MAY-CONTI DIVISION SUBDIVISION

Engineering Comments: FINAL PLAT COMMENTS (should be addressed prior to submitting the FINAL PLAT for review and/or signature by the City Engineer):

DETAIL SITE PLAN

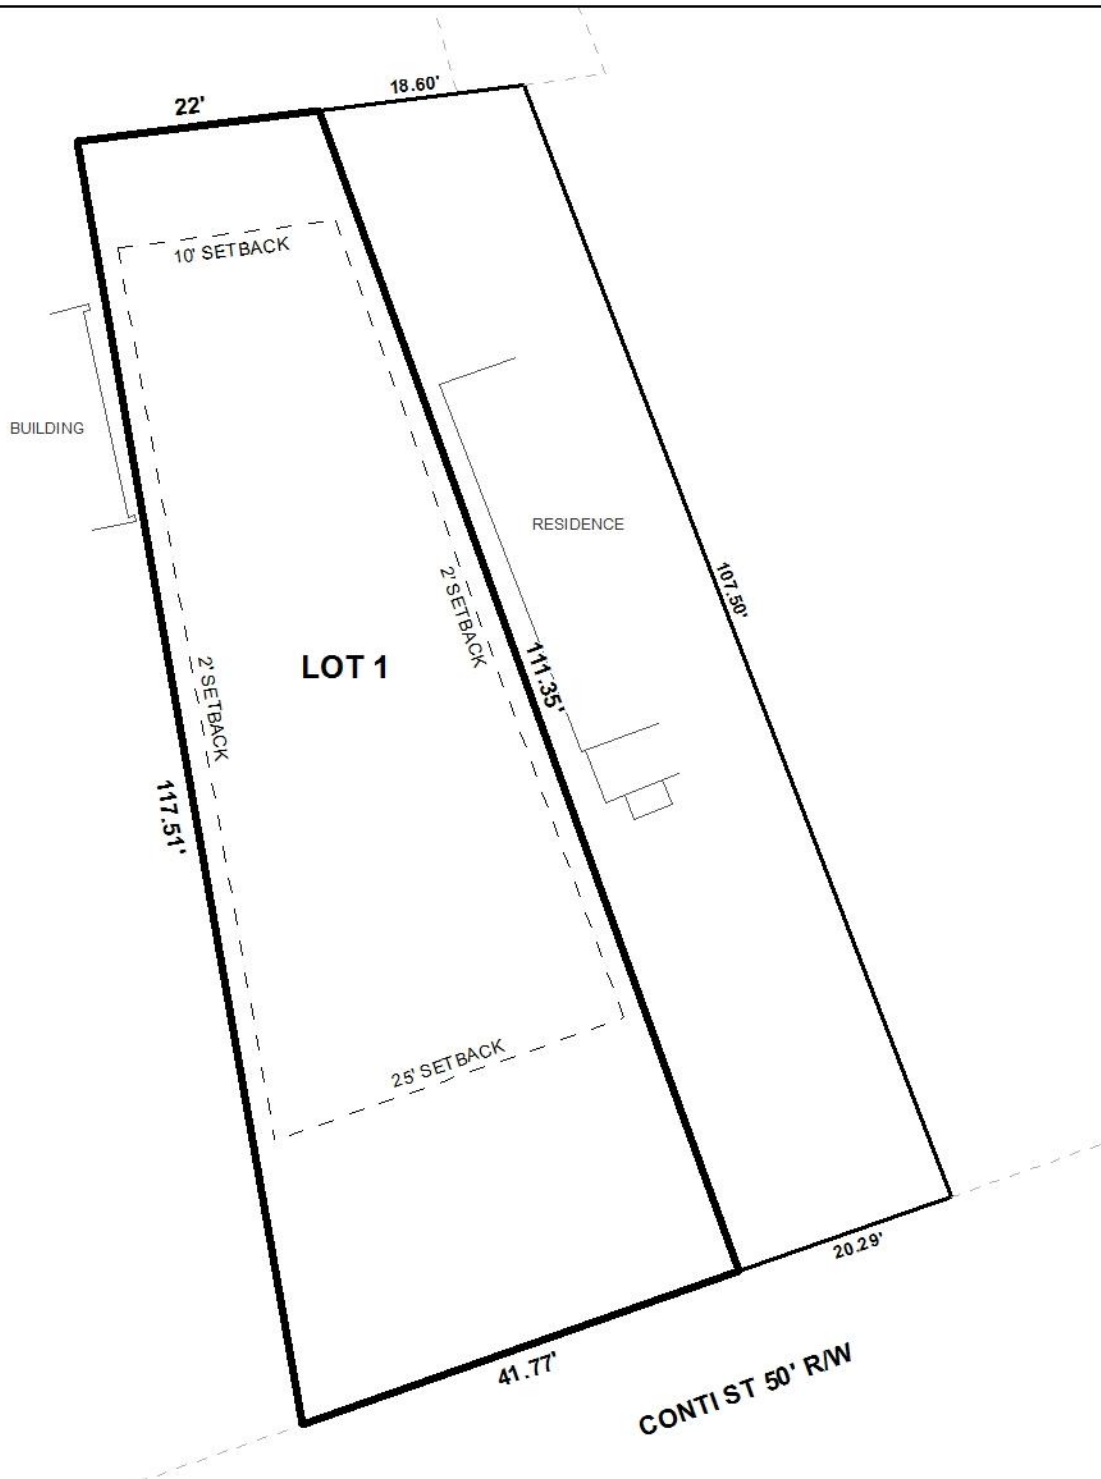
- B. Label COMMON ST on the vicinity map.
- C. Show and label all flood zones.
- D. Show and label the MFFE (Minimum Finished Floor Elevation) on each lot that contains an AE, V, or X (shaded) flood zone designation.

The proposed lot fronts Conti Street, a minor street with a compliant 50' right-of-way; therefore, no dedication would be required. The standard 25' minimum building setback line, required by Section V.D.9. of the Subdivision Regulations, is shown on the preliminary plat. As the site is located within the Old Dauphin Way Historic District, the more flexible Historic District Overlay setbacks of the Zoning Ordinance are applicable, and the applicant has elected to use such for the side yard setbacks. They would also be applicable to the front setback, if chosen. As the applicant proposes to relocate a dwelling from another site to the subject site, and as the adjacent dwelling is 1.8' off the side property line, that dimension may be used for the minimum side yard setbacks on the subject site.

The proposed lot is 3,617 square feet, which is below the minimum 7,200 square feet required by Section V.D.2. of the Subdivision Regulations. However, as the site is located within an older section of the city where many substandard size lots exist, the allowance of the proposed lot size would be in character and would seem justified. Therefore, a waiver of Section V.D.2. would seem in order. As on the preliminary plat, the lot size label in both square feet and acres should be retained on the Final Plat, or a table should be furnished on the Final Plat providing the same information.

As a means of access management, a note containing the Traffic Engineering comments should be placed on the Final Plat.

Based upon the preceding, and with waivers of Sections V.D.2. and V.D.9., the plat meets the minimum requirements of the Subdivision Regulations and is recommended for Tentative Approval, subject to the following conditions:

- 1) provision of a front building setback line, in compliance with the Historic District Overlay standard;
- 2) retention of the lot size label in both square feet and acres, or the furnishing of a table on the Final Plat providing the same information;

- 4) placement of a note on the Final Plat stating the Traffic Engineering comments: *(Lot is limited to one curb cut with size, location and design to be approved by Traffic Engineering and conform to AASHTO standards.);*
